BEFORE THE PUBLIC UTILITY COMMISSION

Docket No. LC 70

2019 Integrated Resource Plan

Staff's Initial Comments

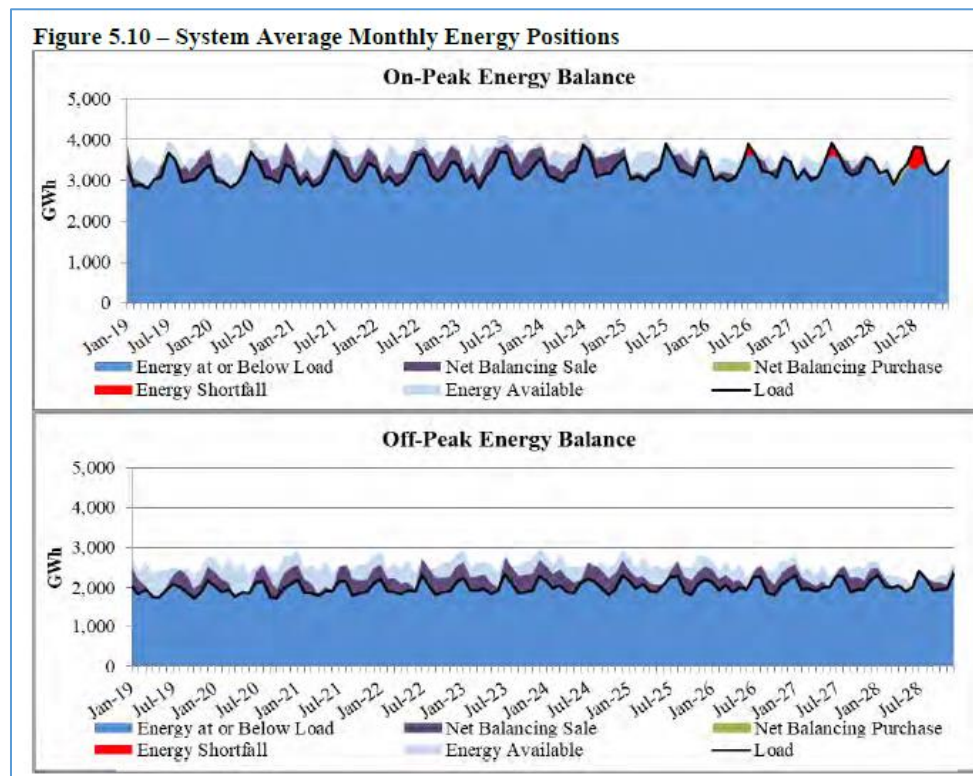
The figures appear to show very low levels of market purchases, and Staff intends to review these results to better understand why market purchases are not more prominent.

Figure 5.4 – Winter Peak Capacity Contribution Values for Wind and Solar

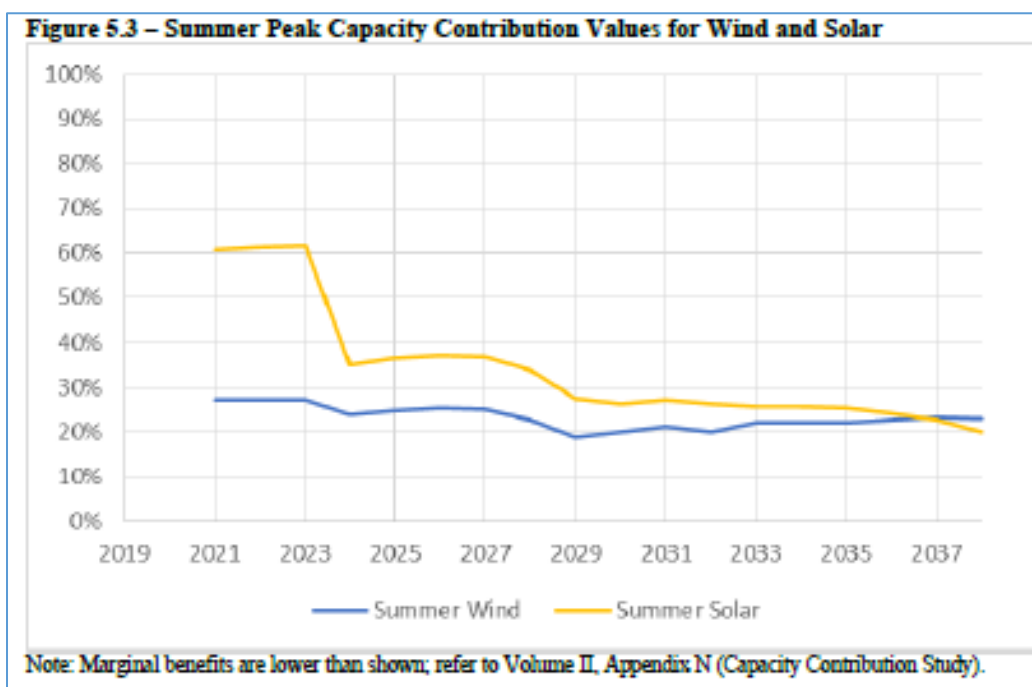
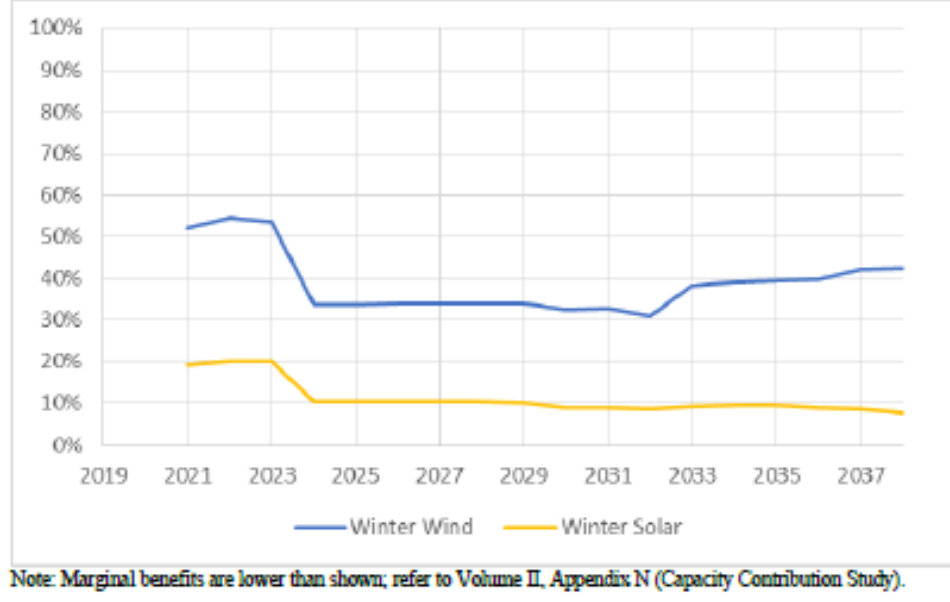
While Appendix N describes the methods used to derive the capacity contribution of wind and solar, Staff has remaining questions about the capacity contribution calculation and whether it is appropriate for inclusion in the load resource balance study. Specifically, Staff has questions about PacifiCorp's technique of calculating the capacity contribution of wind and solar by first calculating the contribution of all other resources in the portfolio, and then assuming that the remaining capacity in the load resource balance, including the 13 percent planning margin, is equal to the capacity contribution of wind and solar.⁷

Staff will be continuing to review the capacity contribution information in the 2019 IRP to understand if existing and new resources are handled with appropriate consistency, including demand-side resources.

Figure 5.2 – Contract Capacity in the 2019 IRP Summer Load and Resource Balance

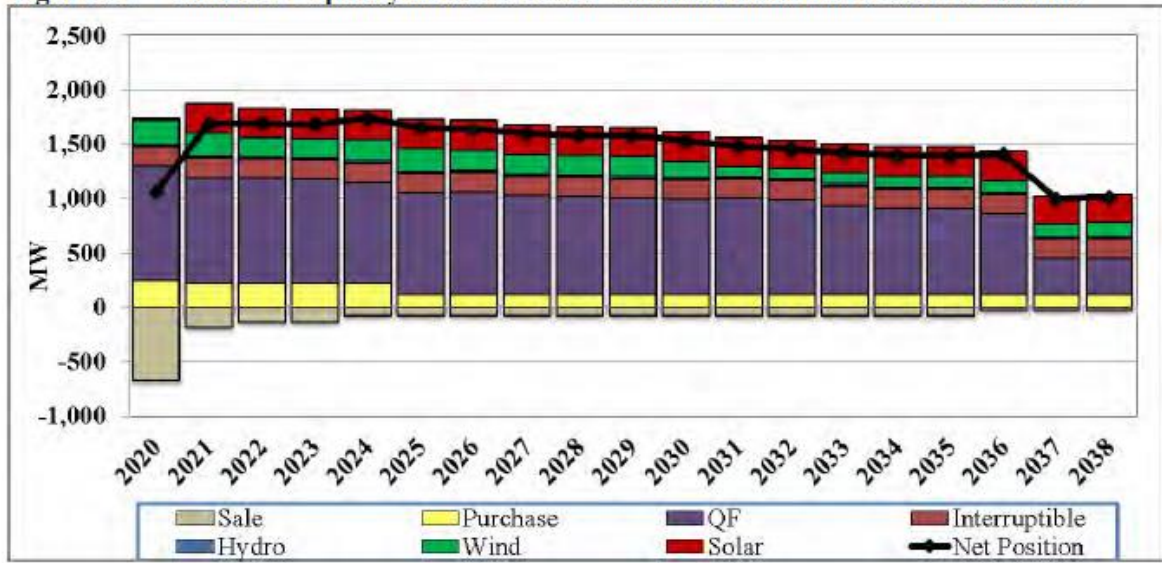
This graph indicates a reduction in sales contracts in 2021, along with an increase in solar contracts. There is also a drop-off in 2037 from expiring Qualifying Facility (QF) contracts. Staff is interested in reviewing PacifiCorp's assumptions about contracts and their contribution to peak capacity as part of the 2019 IRP review process.

Figure 1 – Resource Retirement/ Contract Expirations

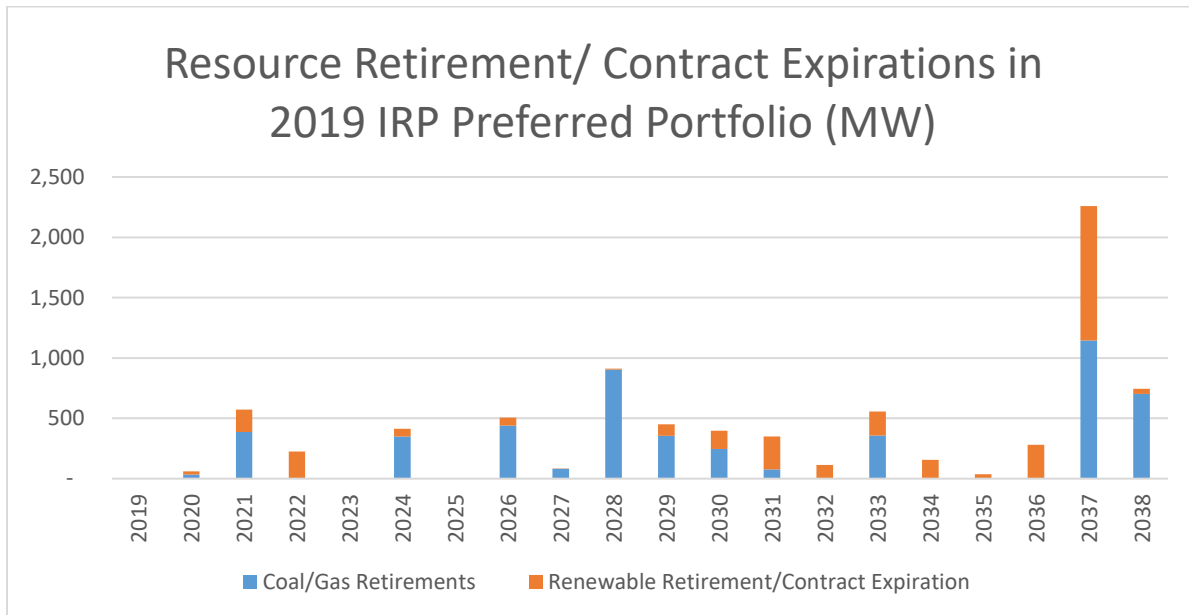
Staff questions the assumptions the Company made about hydroelectric generation losses. In its 2019 IRP, the Company states that it will see 650,232 cumulative lost MWh of hydro generation by 2036.⁸ The Company states that this assumption is based on the decommissioning of the Klamath hydro facilities, as well as relicensing of other projects that could lead to additional operating restrictions imposed in new licenses that could reduce available generation.⁹ Staff has initiated discovery regarding the assumptions used in this calculation and will continue to explore this issue to determine whether PacifiCorp used accurate assumptions in its modeling.

Figure 2 – Customer Count Residential Forecast

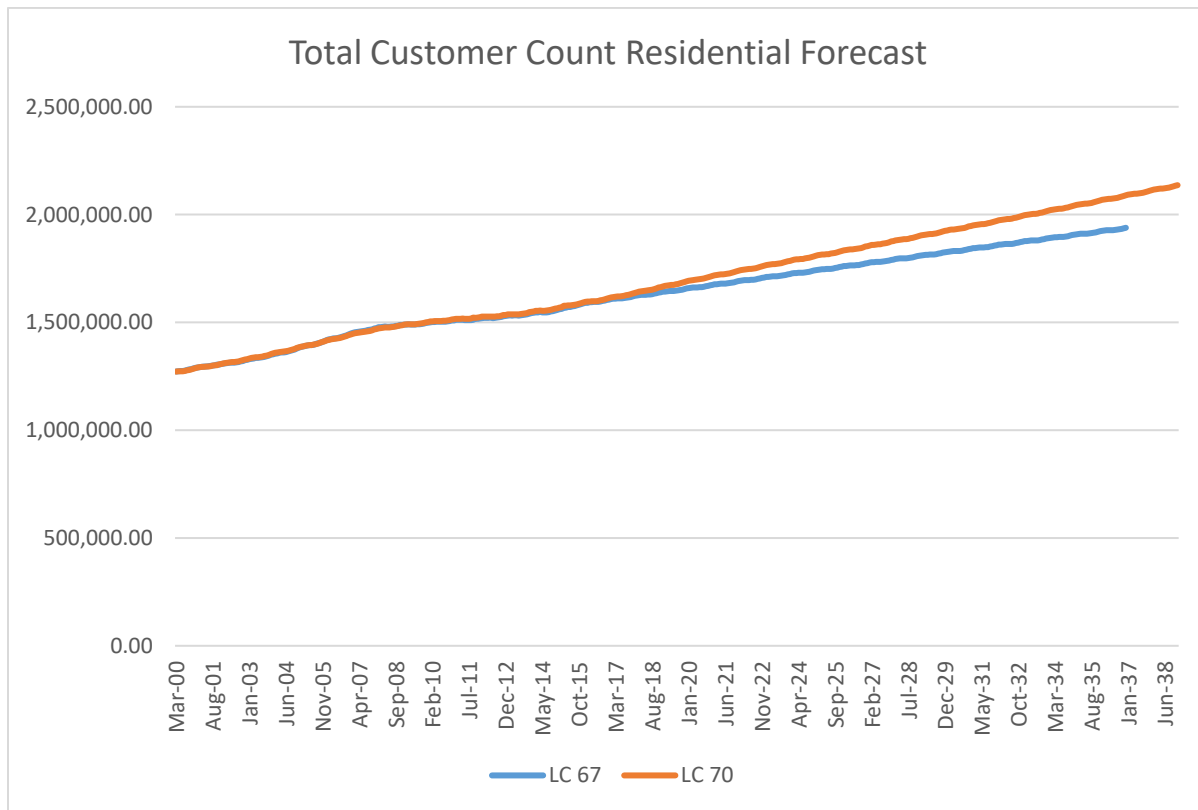
Staff notes, that the “in-sample” forecasts are nearly identical; however, this period displayed a clear advantage in forecast ability in the LC 67 model. When looking at the “out-of-sample” forecast, the difference is noticeable. This shows that as the forecast horizon extends, the differences between the two models and their relative accuracy will become more important. Further, not only do the actual forecasts deviate, but very likely the forecast errors will as well.

Figure 3 – Out-of-Sample MAPE

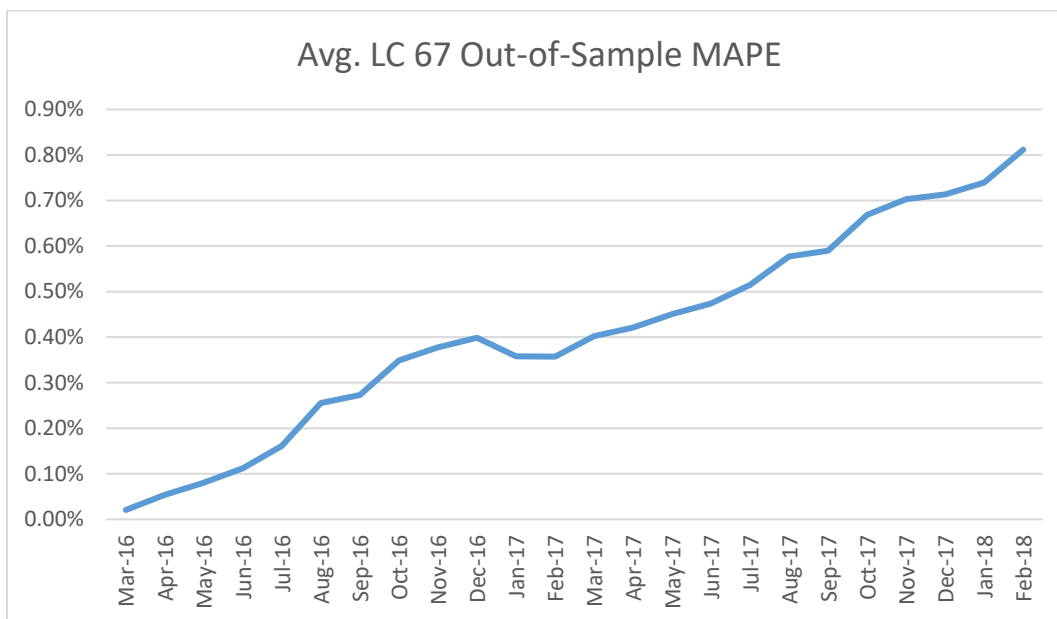
Figure 3, above, provides the average MAPE for the LC 67 forecasts during the interim period between the two IRP's.¹⁴ Staff notes that the error grows nearly monotonically as the forecast extends. If this trend were to continue to the end of the forecast horizon for this IRP, this would equate to a roughly eight percent forecast error for December 2038, or about 140,161 MWh in the single month. Given that the non-differenced model was more accurate in all states, Staff would expect the forecast error to be even larger for the LC 70 model in 2038. Because the Company did not make the change to deal with non-stationarity, Staff does not understand the reason for the change.

Staff notes that the model change has had what appears to be rather large implications for the final forecast. For example, the Utah customer count forecast increased by over seven percent in December 2036 when comparing the LC 70 and LC 67 forecasts. However, the main driver of the forecast, the IHS population forecast, decreased by over 4.5 percent in 2036 from the 2017 forecast to the 2018 forecast.^{15, 16}

Figure 5 - Navigant PG Study Payback Acceptance Curves²⁴

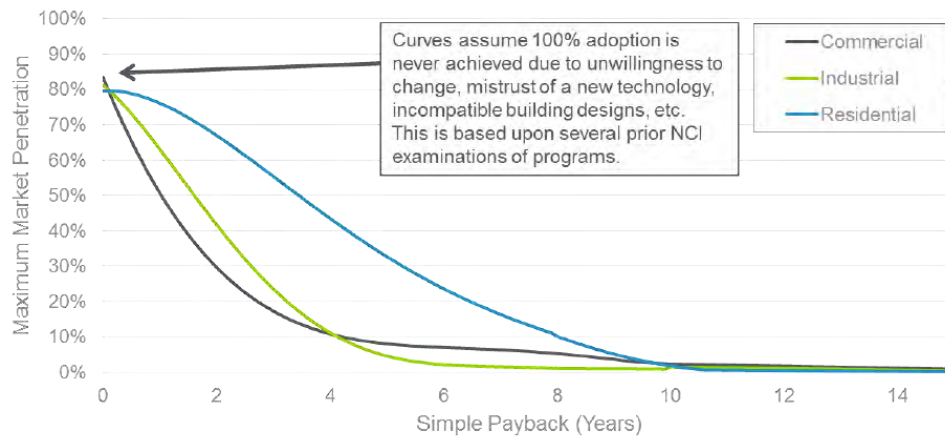
These assumptions appear more conservative than those used by other PG forecasts. For example, the Navigant study assumes an 80 percent maximum market penetration and almost no commercial adoption beyond a four year payback period. However, NREL's dGEN model assumes a 90 percent maximum market share with non-residential adoption well above the Navigant assumptions up to 10 years.

Figure 7 - PV Watts Monthly Output for a 5 kWdc Solar Shape in Salt Lake City, UT²⁷

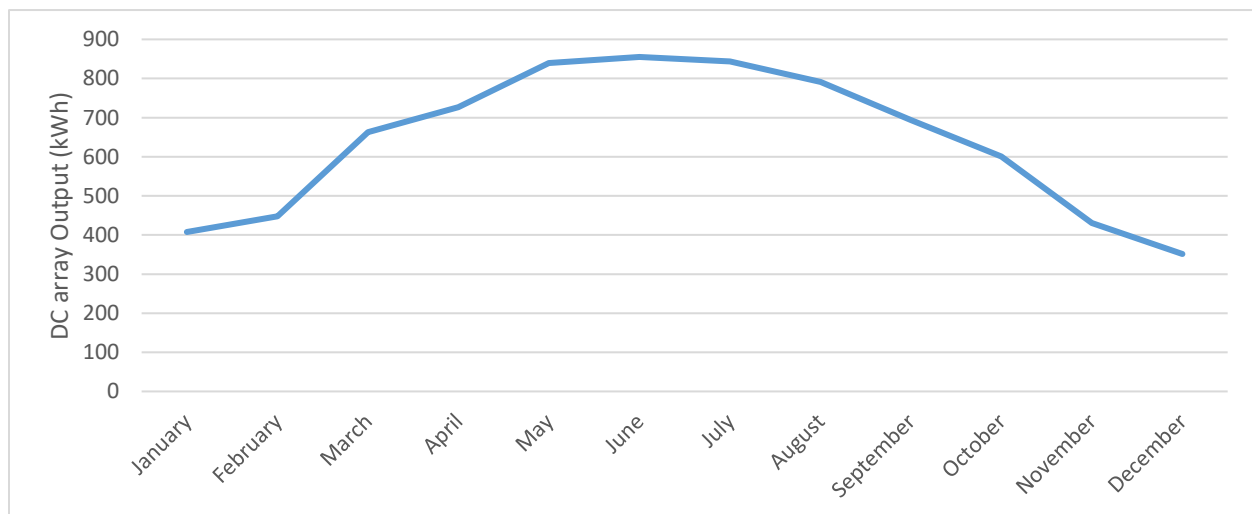
Staff is also investigating the Company's assumptions related to PG resource performance in the winter. In the load-resource balance, PAC indicates that the winter contribution of Private Generation in 2025 is 3 MW in the East and 1 MW in the West, as compared to a summer contribution of 188 MW and 39 MW respectively.²⁶ As illustrated in Figure 7 and Figure 8, distributed solar resource generation is typically lower in the winter; however, this level of seasonal variation is likely not at a scale of 3:188 when considered monthly or hourly. Staff will continue to investigate the underlying analysis to determine if the PG forecast is understating the winter contribution of these resources.

Figure 9 – Comparison of Load vs. Energy Efficiency

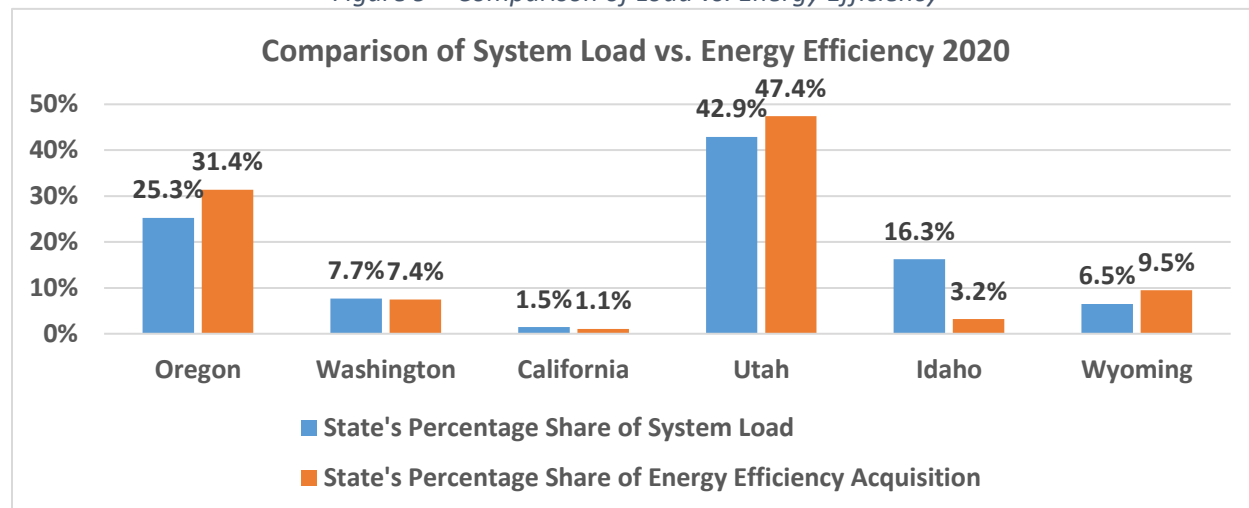
These numbers indicate that energy efficiency selections are disproportionately higher in Oregon compared to its overall share of system load. The discrepancy between energy efficiency selections and system load was noted in Staff's comments in the 2017 IRP.⁷² Staff is concerned that not only are energy efficiency activities subsidizing system benefits to other states, but that Oregon ratepayers are also not seeing the system benefits from cost-effective energy acquisitions that are not being pursued in other states. The following graph illustrates the disproportionate share of Oregon energy efficiency over the study period and how the disparity has increased since the previous IRP, indicating that a concern identified by Staff in the previous IRP has only grown in severity.
